MONTEBELLO ESTATES JSP15-76

Public hearing at the request of Mirage Development for Planning Commission's approval of Preliminary Site Plan, Woodlands Permit, Wetlands Permit and Stormwater Management Plan. The subject property is currently zoned R-3, One-Family Residential and is located in Section 27, west of Novi Road and north of Nine Mile Road. The applicant is proposing a 33 unit single-family detached residential development on a 26.94 acre property.

Re: Montebello Estates (JSP15-0076)
Wetland Review of the Preliminary Site Plan (PSP15-0176)

Figure 2. Previous iteration of Site Development Plan, provided by Seiber, Keast Engineering, L.L.C. Delineated wetland areas are indicated in green and (approximate) watercourse centerlines are shown in blue.

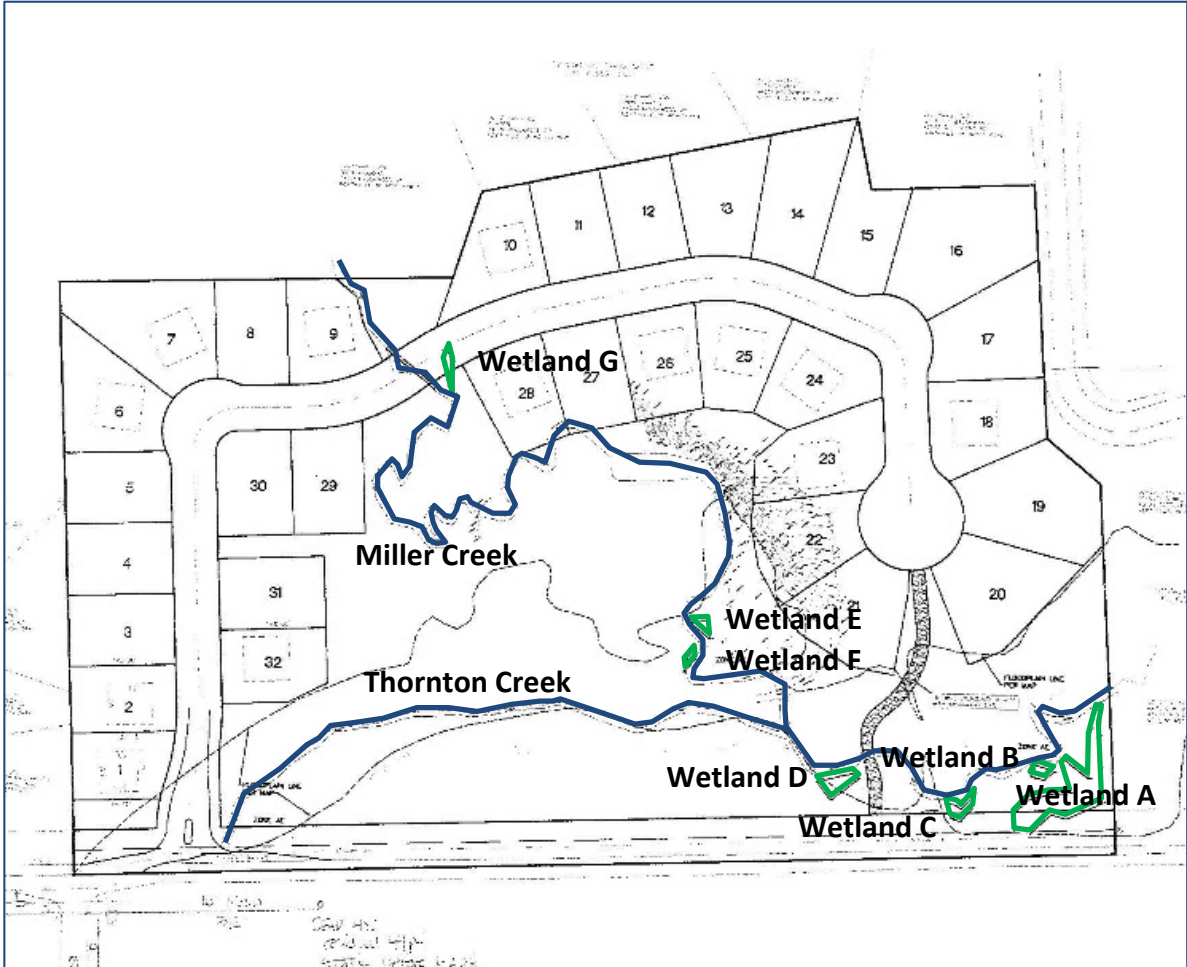
Currently, the Plan indicates impacts to one (1) of the seven (7) on-site wetlands (i.e., Wetland G, see Figure 2). The Plan proposes to fill Wetland G (0.01-acre), located in the northern section of the site, for the purpose of constructing a section of Montebello Court as well as Lot 29. For the same purpose, the Plan proposes to relocate 230 lineal feet of Miller Creek, re-routing the Creek via a proposed culvert (approximately 85 lineal feet).

In addition to this proposed wetland impact and proposed impact to Miller Creek, the Plan appears to propose impacts to regulated floodplain. This includes approximately 1,737 square yards of wetland fill (~800 cubic yards) in the southwest corner of the property for the proposed entrance from Nine Mile Road. Although not quantified on the Plan, there also appears to be proposed floodplain excavation for the purpose of constructing proposed stormwater detention basin “A” in the southern/central portion of the site. Floodplain impacts will most likely need to be authorized by the Michigan Department of Environmental Quality (MDEQ). As with wetland impacts, all area (square feet) and volume (cubic yards) impacts to floodplain shall be indicated on the Plan.

In addition to this proposed wetland impact (i.e., filling Wetland G), the Plan indicates a total permanent wetland buffer impact of 0.47-acre of the total 5.26 acre on-site wetland buffer area (approximately 9% of the total wetland buffer area) for the purpose of constructing Montebello Court as well as Lot 28 and a proposed (pedestrian) access to Nine Mile Road in the southeast section of the site.
